PLANS AND DOCUMENTS referred to in the PDA DEVELOPMENT APPROVAL

Approval no: DEV2025/1629

AMENDED IN RED

Lot 526, #11 Quest Lane
Clinton

SITE AND DRAINAGE PLAN

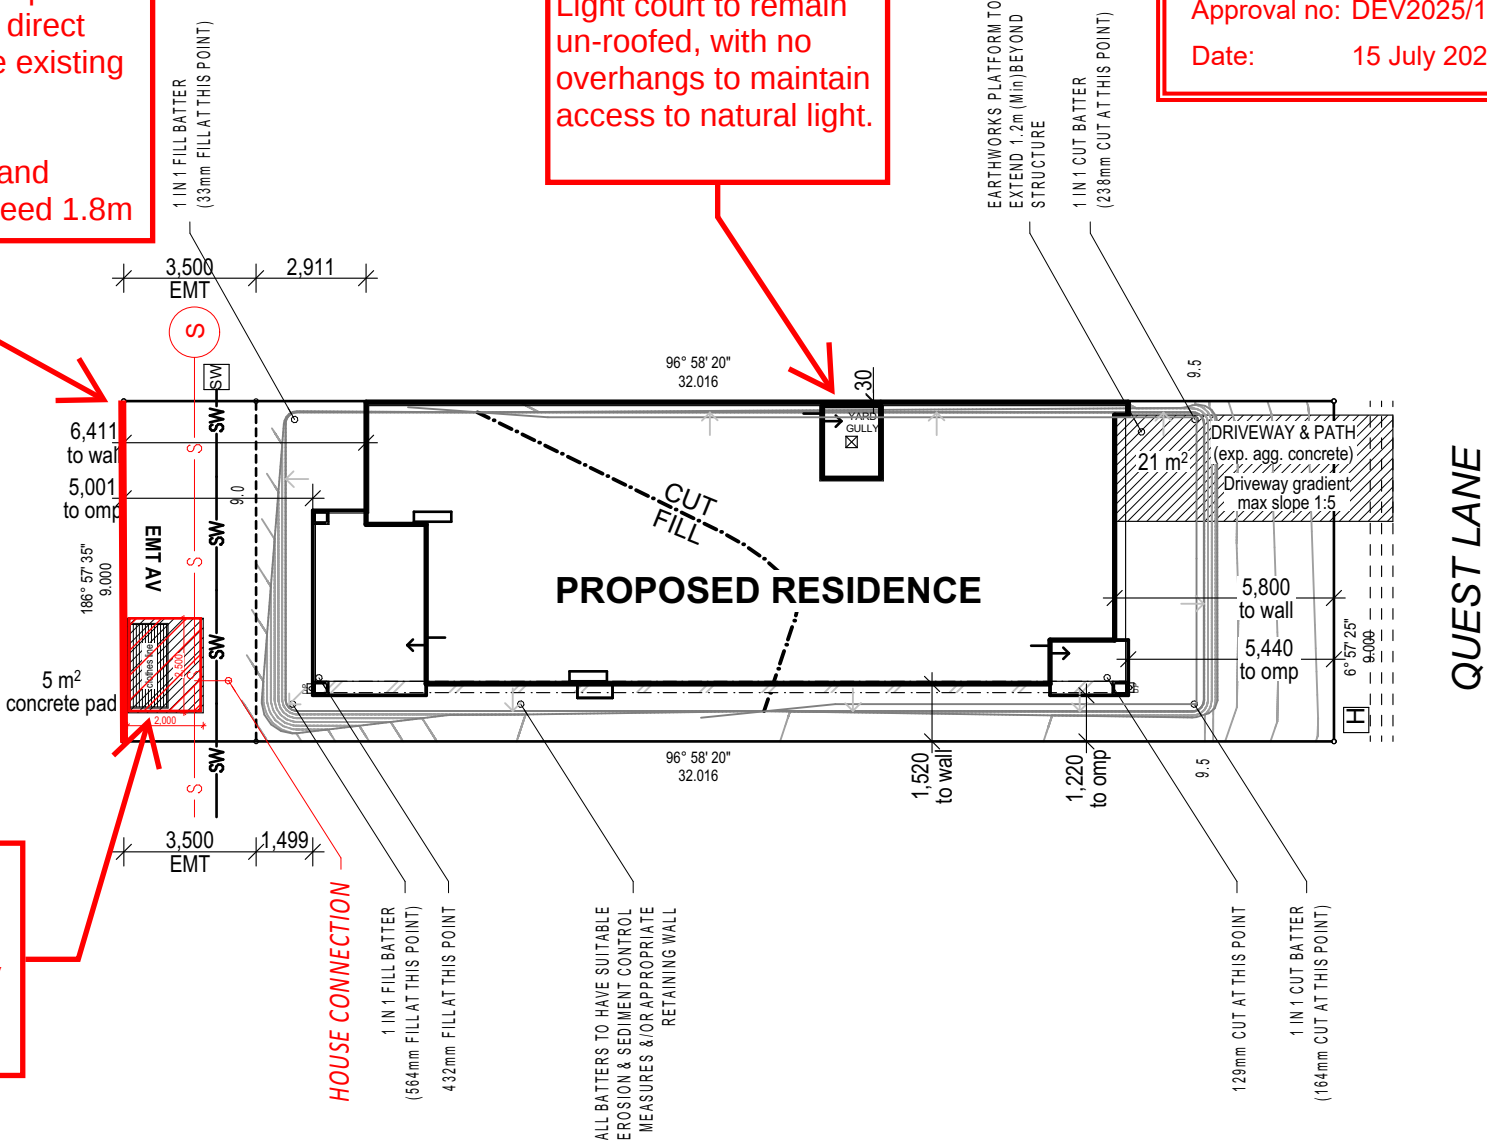
Front fence along the Harvey Road Frontage is required to remain a minimum of 50 percent transparent and is to include a gate for direct pedestrian access from the existing stairs.

Combined height of fence and retaining wall must not exceed 1.8m

Light court to remain un-roofed, with no overhangs to maintain access to natural light.

Clothes line location not approved.

Clothes line may only be located on side boundary fences.
